Serial: NPD-NRC-2011-061
July 14, 2011

**LEVY NUCLEAR PLANT, UNITS 1 AND 2
DOCKET NOS. 52-029 AND 52-030
VOLUNTARY SUBMITTAL RELATED TO THE PIPELINE HAZARDS ANALYSIS DESCRIBED
IN CHAPTER 2 OF THE FINAL SAFETY ANALYSIS REPORT**

The text in subsection 2.2.2.3, Description of Pipelines, will be revised from:

FIGURE 2.2.2-202

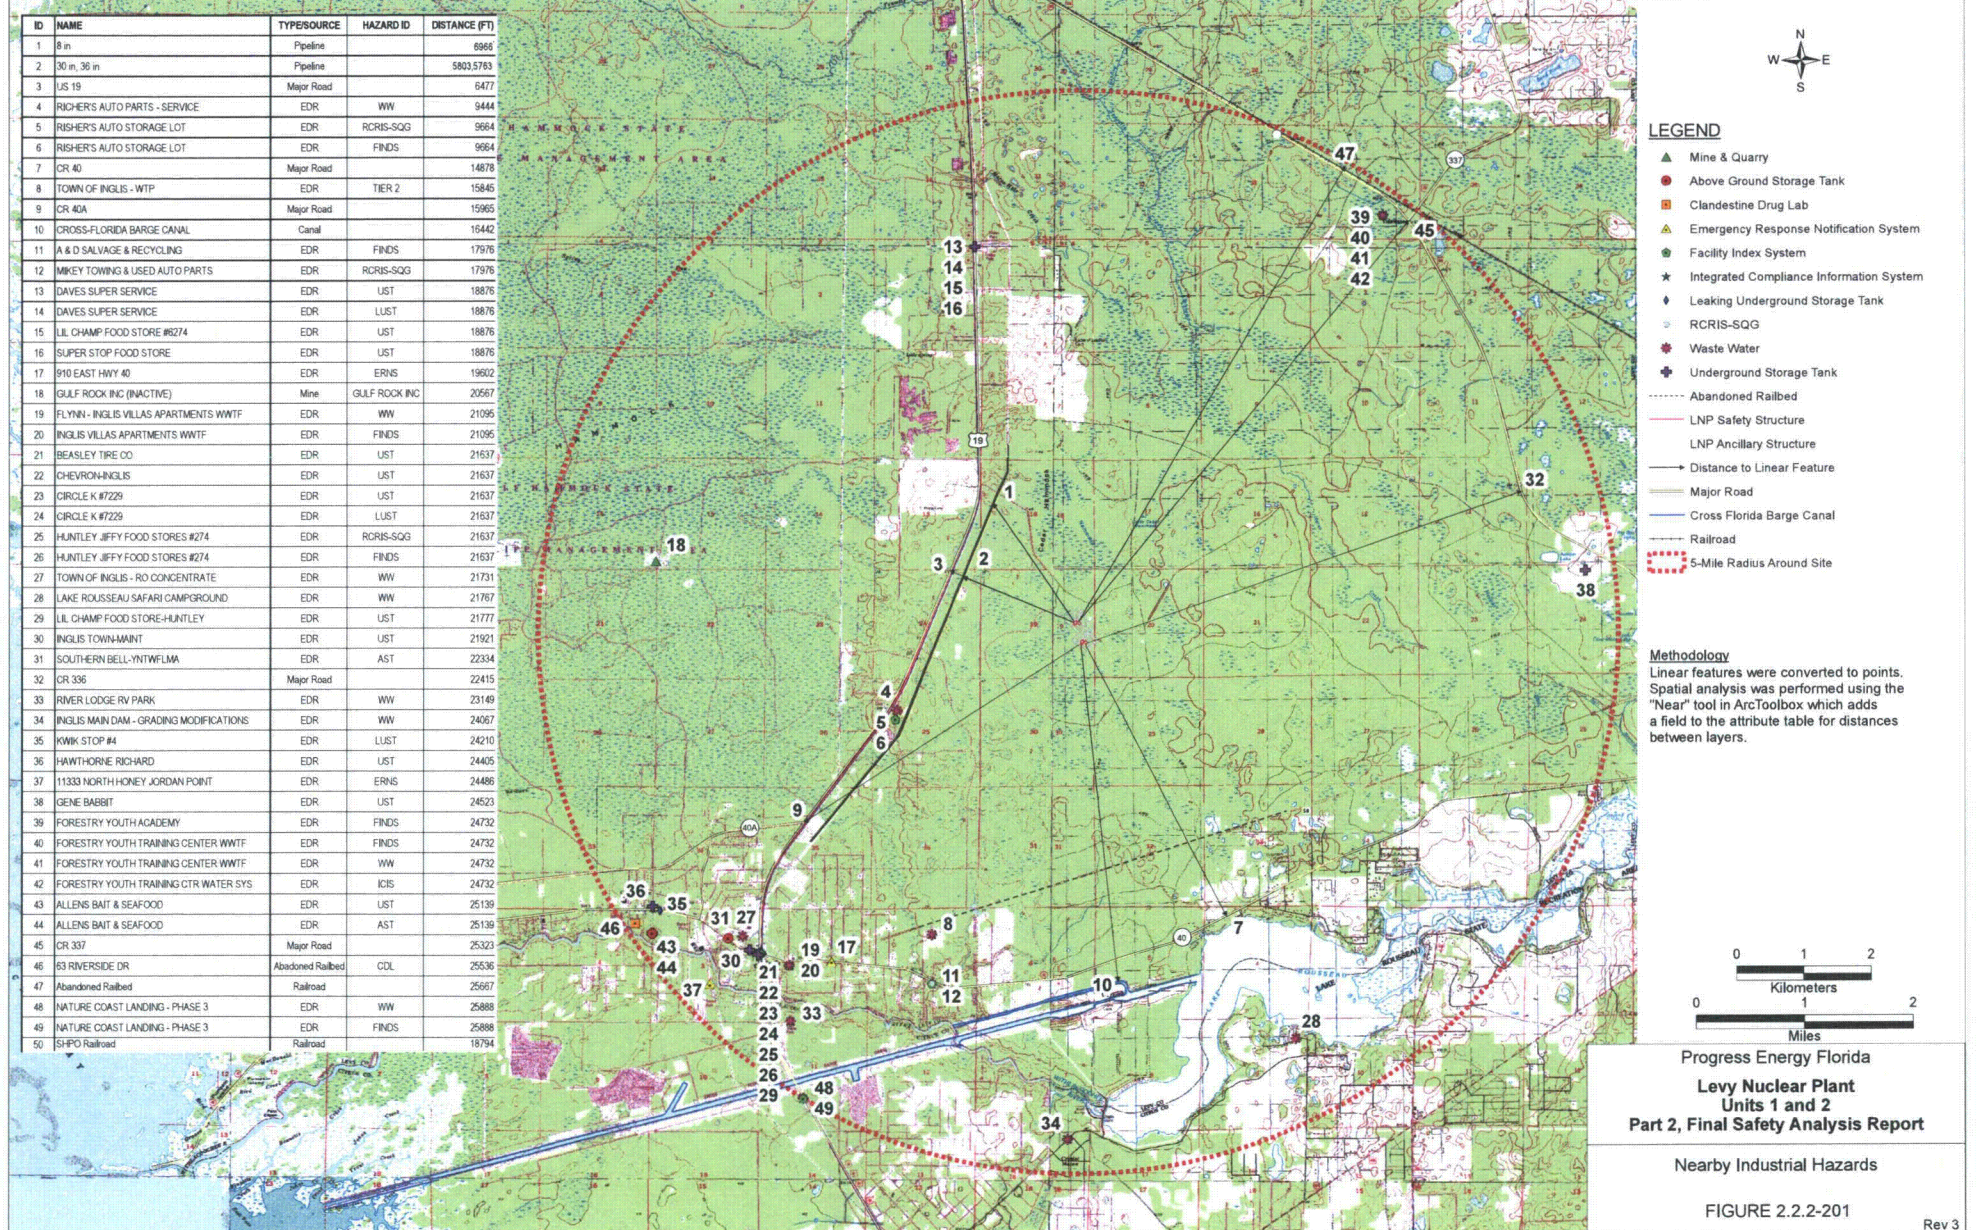
There are three natural gas pipelines in the area of LNP as shown on [Figure 2.2.2-202](#). There is a 20.3-cm (8-in.) pipeline lateral that splits from a 76.2-cm (30-in.) pipeline 2123 m (6966 ft.) northwest of LNP and runs to the north-northeast from LNP. It normally operates at or below 912 psi. Because the 20.3-cm (8-in.) pipeline is smaller and a greater distance from the plant, the accident analysis for this pipeline is considered to be bounded by the accident analysis for the 91.4-cm (36-in.) pipeline described below and does not require additional consideration.

The 91.4-cm (36-in.) pipeline runs parallel to the 76.2-cm (30-in.) pipeline, is located to the west of the site and runs from the south-southwest to the north-northeast. It is 1757 m (5763 ft.) from the nearest location of the LNP safety-related structures at its closest approach west-northwest of the site as shown on [Figure 2.2.2-201](#), and has a maximum operating pressure of 1333 psi.

FSAR Figure 2.2.2-202, Revision 3, Distance to FGT Pipelines.
